BULGA SURFACE OPERATIONS EASTERN EMPLACEMENT AREA MODIFICATION

Response to Submissions

December 2016

Figure 2.1 Revised Tailings Emplacement Location

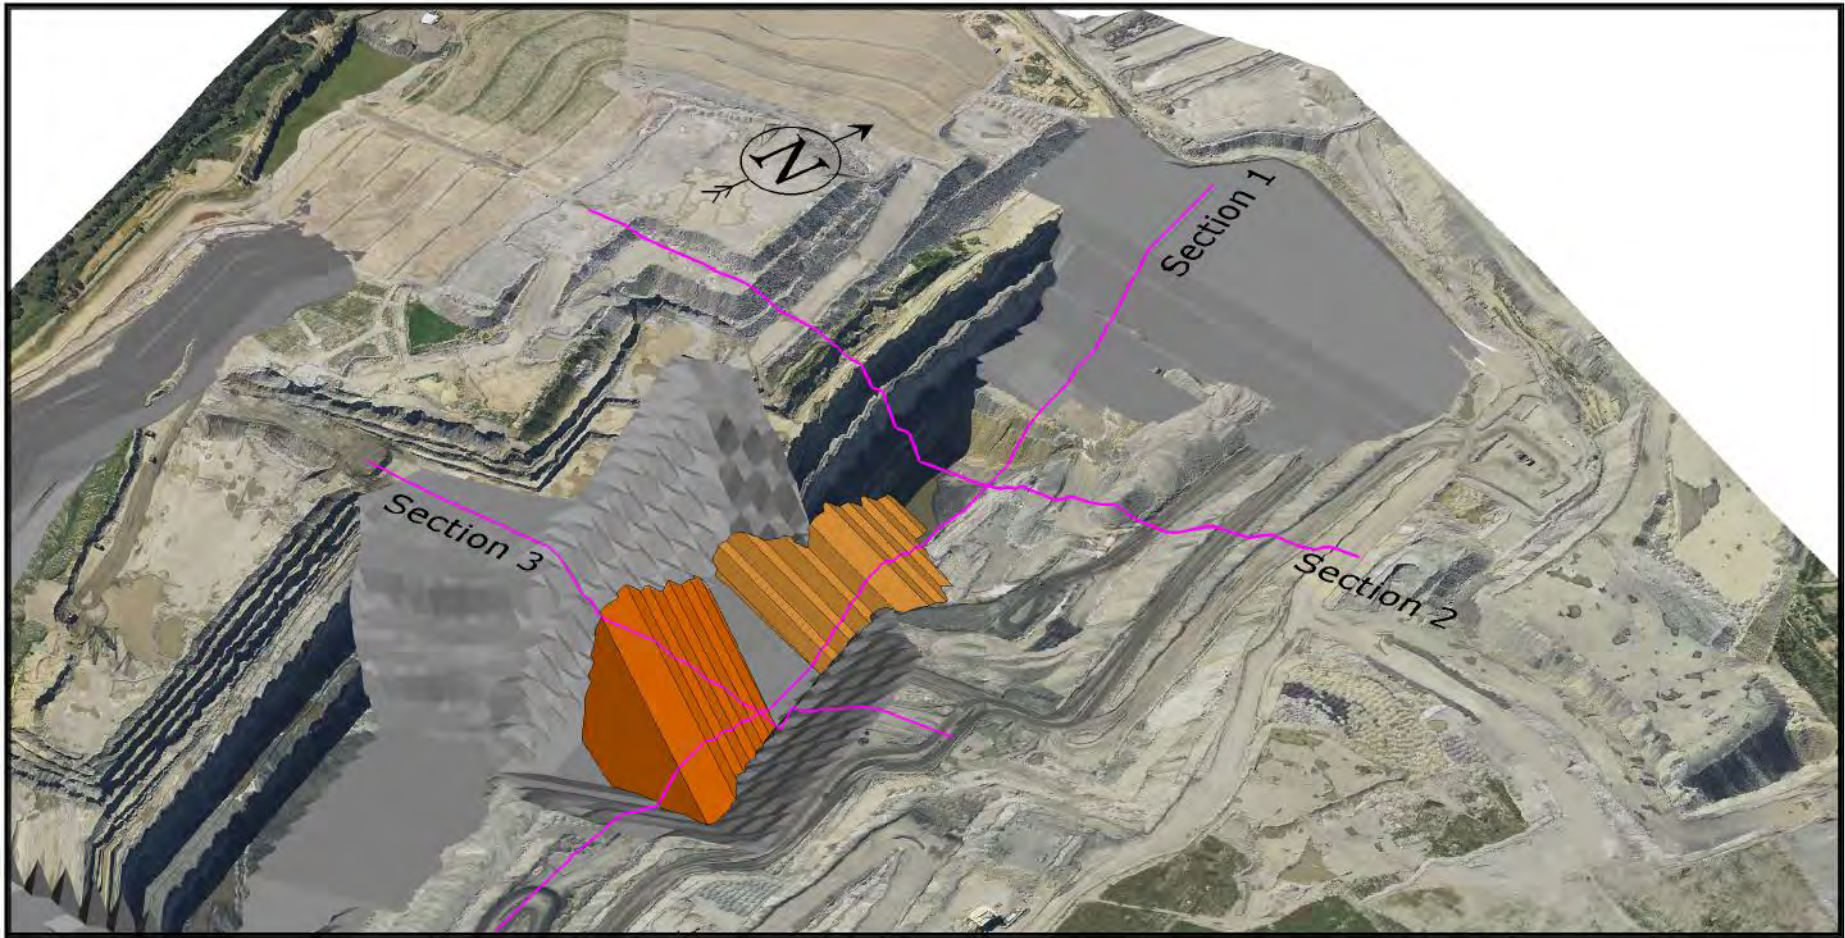
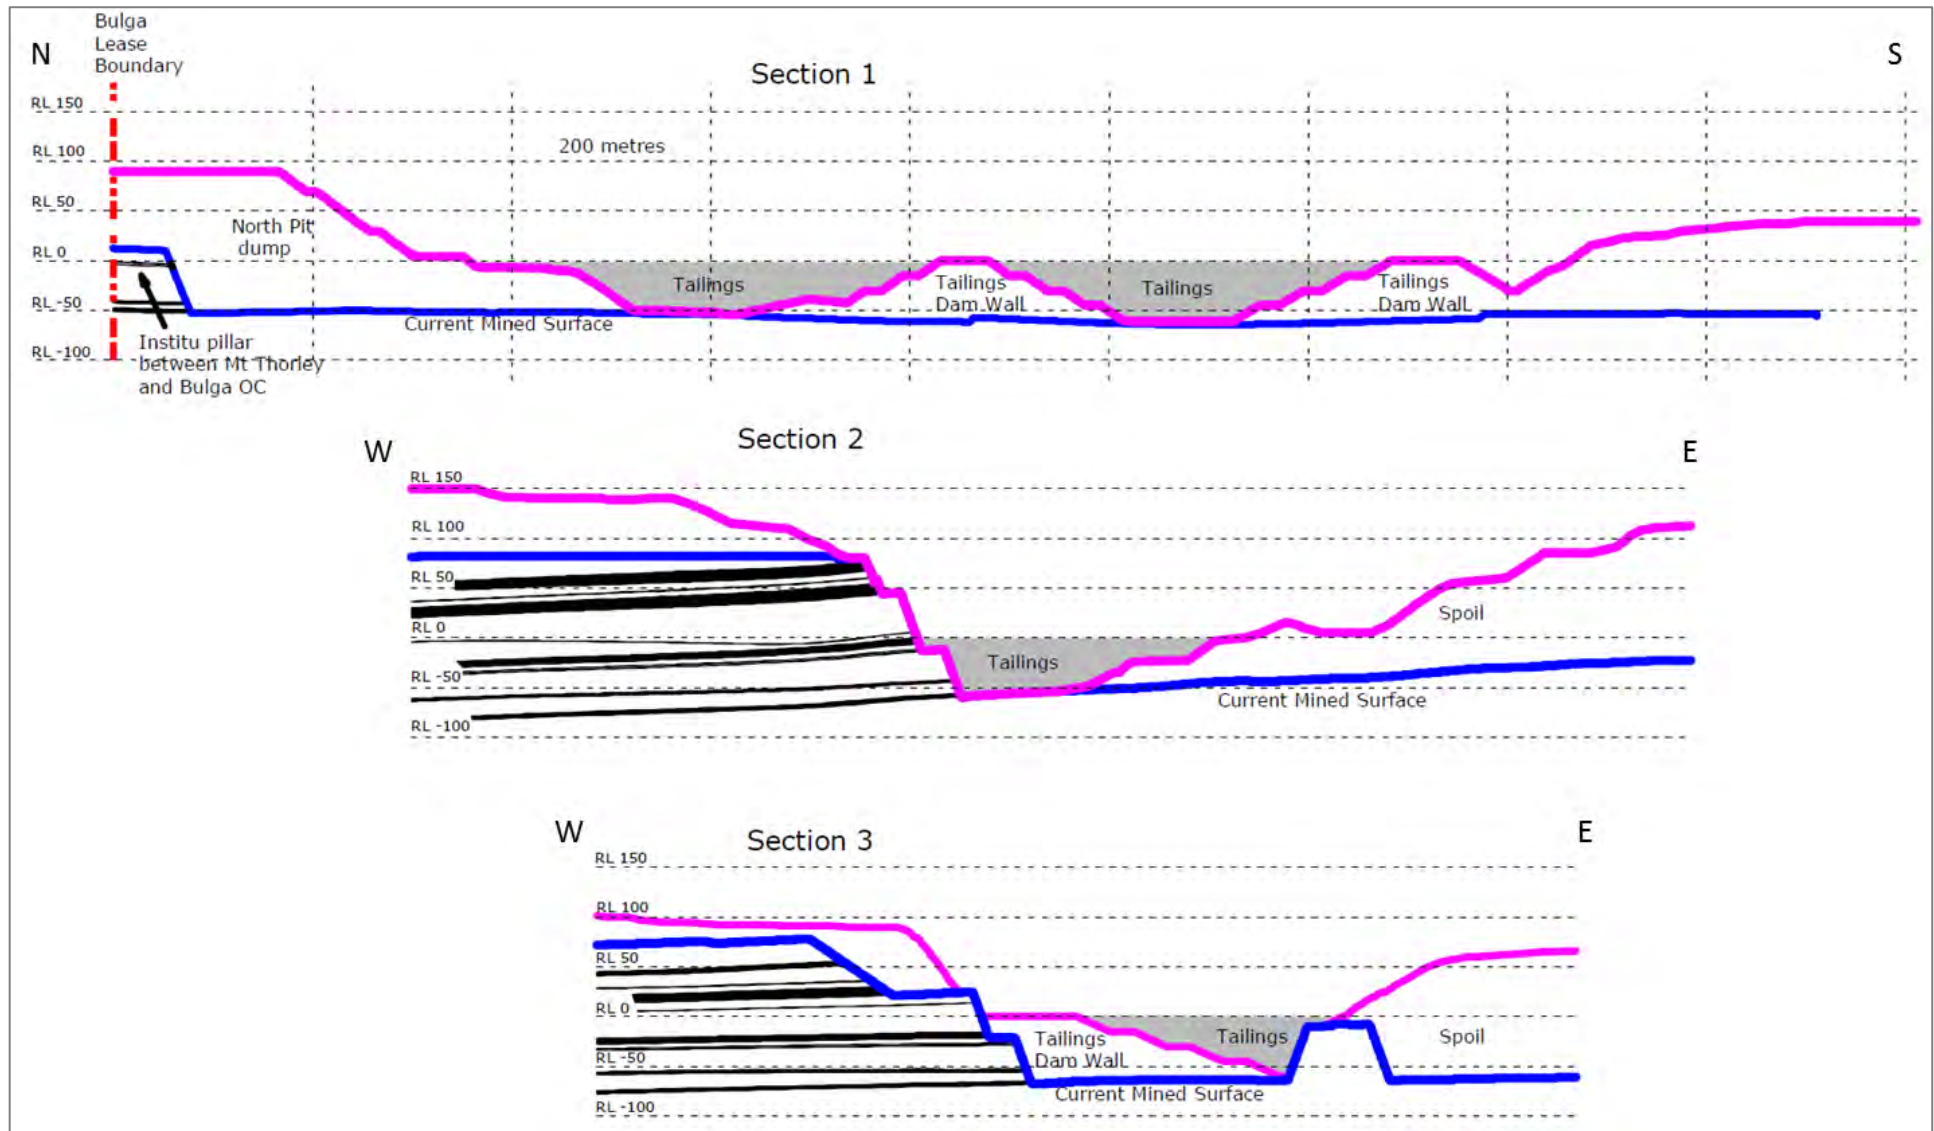
The approved tailings strategy for the Bulga Surface Operations includes emplacement of tailings into the underground workings. As outlined in the SEE, as a result of the decision to suspend mining operations at the Bulga Underground, it has also become necessary to develop a revised tailings management strategy.

The proposed revised tailings emplacement location is shown on **Figures 2.1** and **2.2**. Tailings are planned to be deposited into a series of cells at the base of the Main Pit, from approximately -60 mRL up to an approximate elevation of 0 mRL. The total volume of tailings to be emplaced is estimated as 7.5 GL. The tailings emplaced will be in conjunction with other mining waste materials such as overburden / interburden and coarse reject or thickened tailings which are currently co-disposed during backfilling operations.

FIGURE 2.3
Visual Montage Hedly Residence
Final Landform - Eastern Emplacement Area

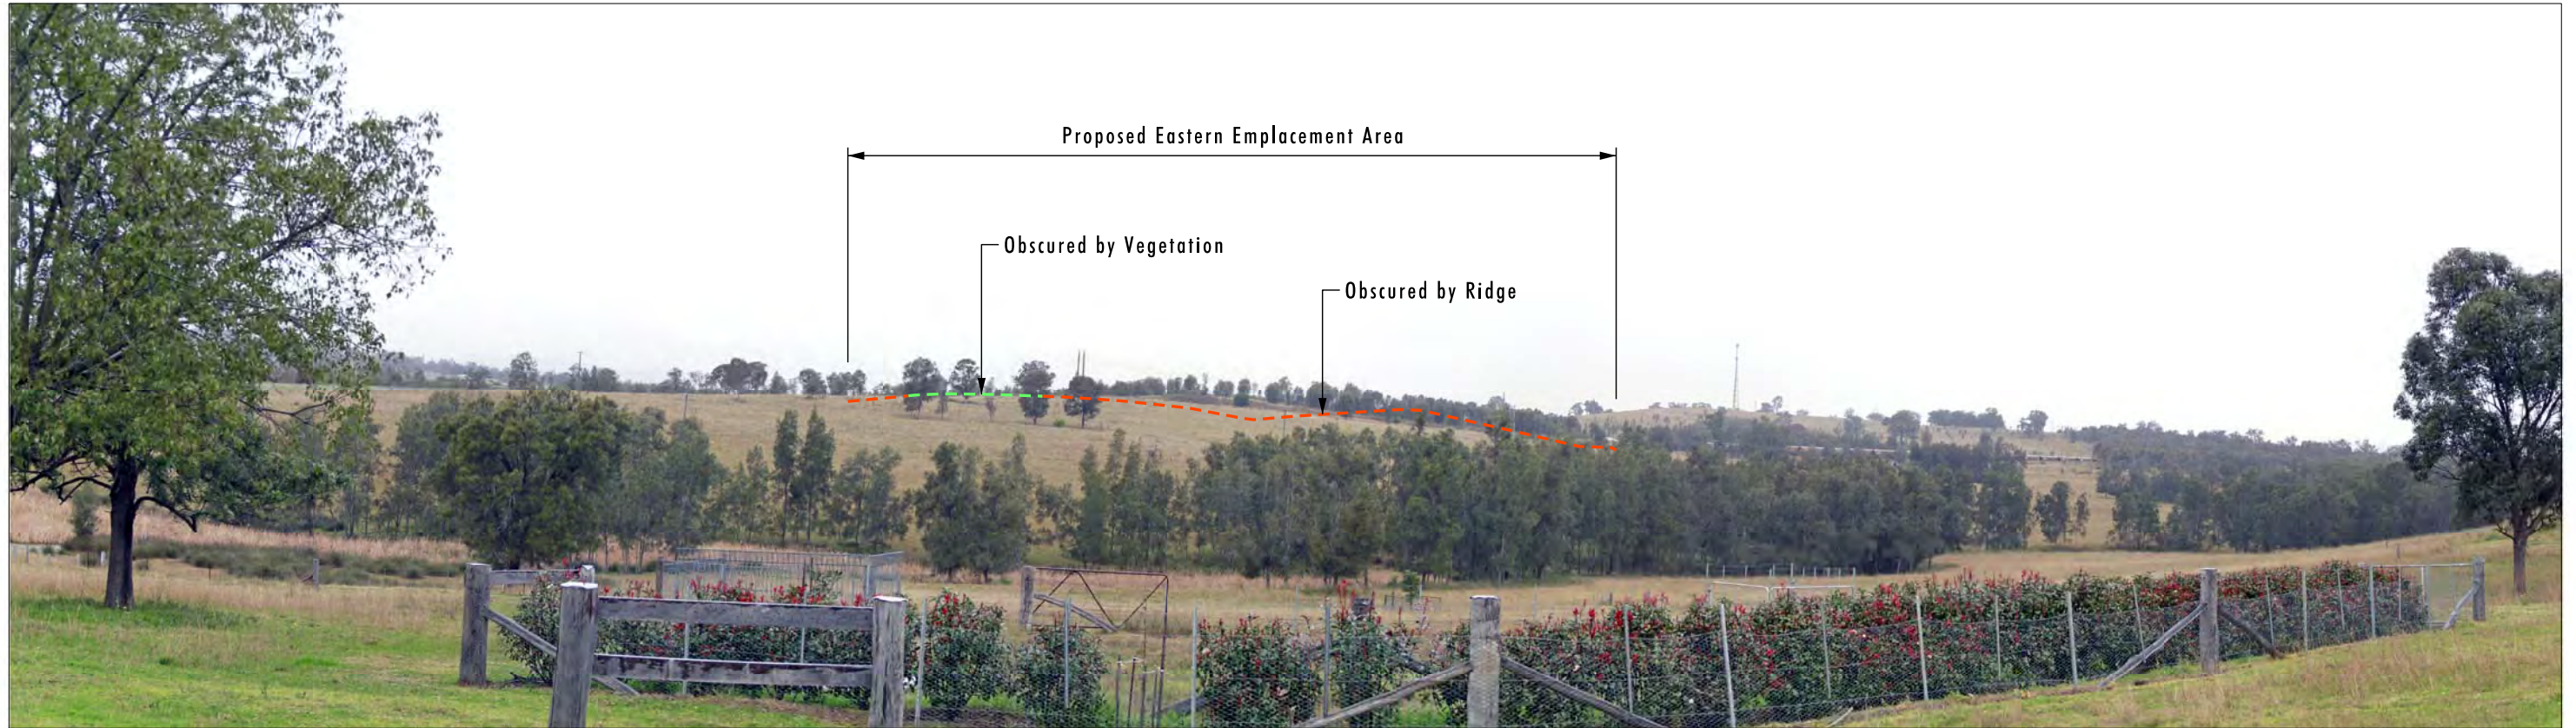
2. The Department requests that Glencore provide a realistic photographic montage to demonstrate that the potential views of the revised EEA would continue to be shielded by these intervening features.

Notwithstanding the above Umwelt has prepared a photomontage from the residence that was identified as theoretically being able to see the EEA. The visual montage, refer to **Figure 2.3** confirms that direct views of the proposed EEA are expected to be obscured by roadside vegetation, existing vegetation on the ridge in the foreground and also the ridge itself. This confirms the assessment findings outlined in the SEE and no further mitigation measures are considered to be required.

FIGURE 2.6
Eastern Emplacement Area
Cross Sections

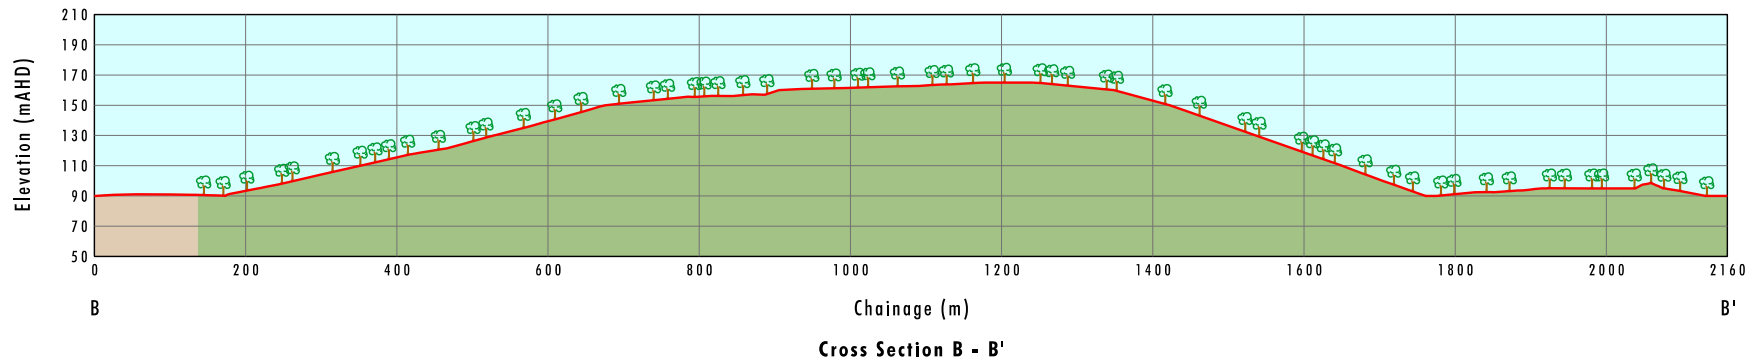
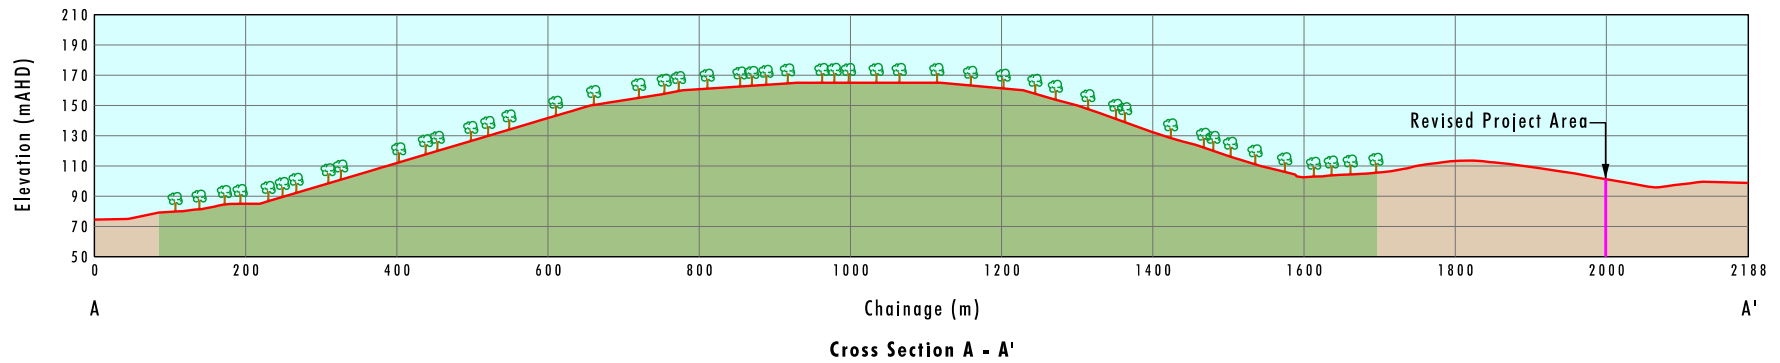
1. Increased Detail and/or modelling of the final landform incorporating:

- The integration of a natural landform, with macro and micro-relief integrated into the final landform
- Maximum opportunities for external water drainage away from final voids.
- Minimise reliance on linear drop structures
- Identification of association risks with the achievement of final landform in regards to its ability of sustaining the intended final land use; and
- Plans and relevant cross- sections to an appropriate scale.

Rehabilitation and closure activities will be implemented progressively throughout the life of mine to maximise any opportunities for the development of other potentially viable land use options. Further, the details of the landform, land use and associated rehabilitation from the BOP EIS have been included into the currently approved Mining Operations Plan (MOP). It is proposed that should the modification be approved, the MOP would be updated to include the modified EEA including more detailed landform plans in accordance with DREs guidelines for MOPs. **Figures 2.5 and 2.6** provide further detail on the proposed final land form and land use for the EEA including cross sections.
